**ZONING MAP CHANGE
STAFF REPORT**

City Council Meeting Date:
May 03, 2016

Owner / Applicant: Harwood Builders, Inc.

LOOP 820 SELF STORAGE

DRAWN: SRH
DATE: 01/18/16
HEI #: 16-106
SHEET NO: C1

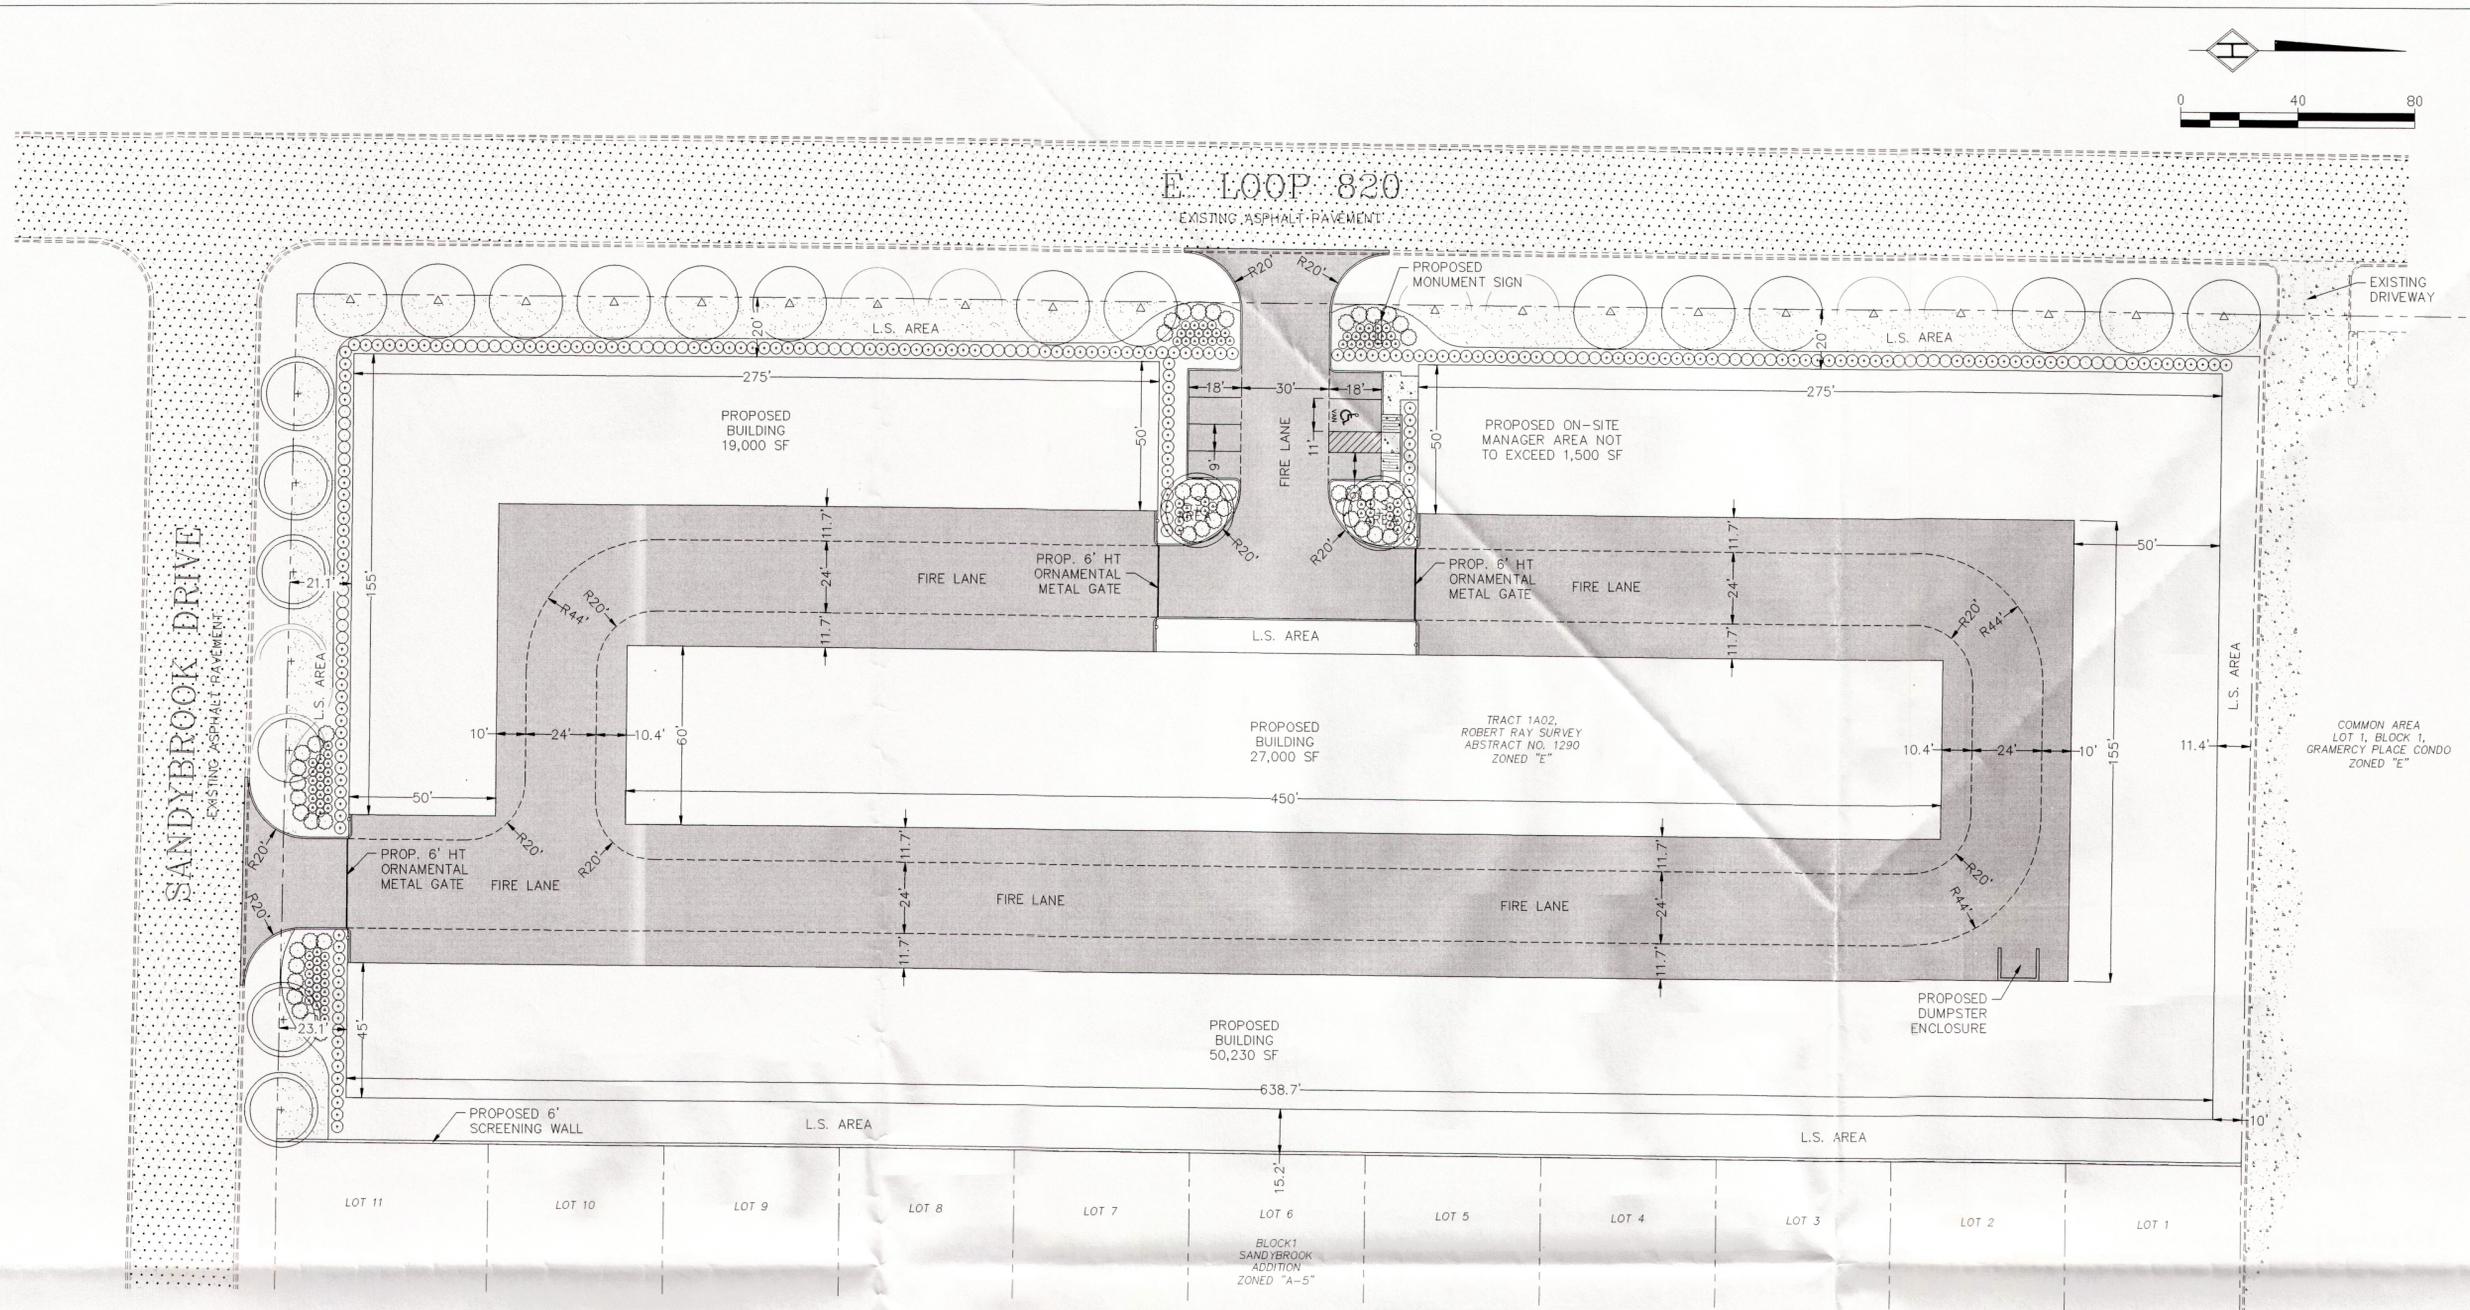
The site plan as submitted is not in general compliance with the zoning regulations.

1. There is a 20 ft. supplemental setback along the east property line in which no permanent structures are permitted, site plan indicates 15.2. **(waiver required)**
2. Remove notes # 1, 2, and 6.
3. Since there is a note all landscaping will comply take off the shrubs unless you plan to over plant.
4. Note #5 add will comply with Urban Forestry and remove all trees unless you plan to over plant.

1. Street Dimensions - Show the dimensions of all existing or recorded streets, alleys, easements, railroad ROW, or other public ROW within or adjacent to the subdivision boundaries. The distance from the centerline of the existing roadway of the boundary street to the proposed property line shall be shown.

2. Gated Entrances (Ch. 31-107) - Gated entrances into secured areas must be designed in accordance with TPW's "Traffic Engineering Design Standards and Policy Guidelines". Provisions for an acceptable turnaround must be made. Provide details in IPRC plan set (single-family) or UR site plan (multi-family) for gates. All gates shall be equipped with a Knox-box or other approved fire access apparatus that is reviewed and approved by the Fire Department. (Gates must be located 3 vehicle lengths from the ROW)

3. Show all Sidewalks - Sidewalks and street lights are required for all public and private streets and public access easements as per City of Fort Worth Standards.

1. Water available
2. Pressure guaranteed at ground elevation
3. PRV's due to high water pressure
4. Field verify 16" water line, additional easement may be required
5. Taps done by Miscellaneous Project due to pipe being concrete

1. Sewer available
2. No permanent structures over, under, encroaching 6" sewer line and easement at NE PL
3. Field verify 6" sewer line L-8294, additional easement may be required

Zoning Commission recommended a waiver to item #1 noted above.
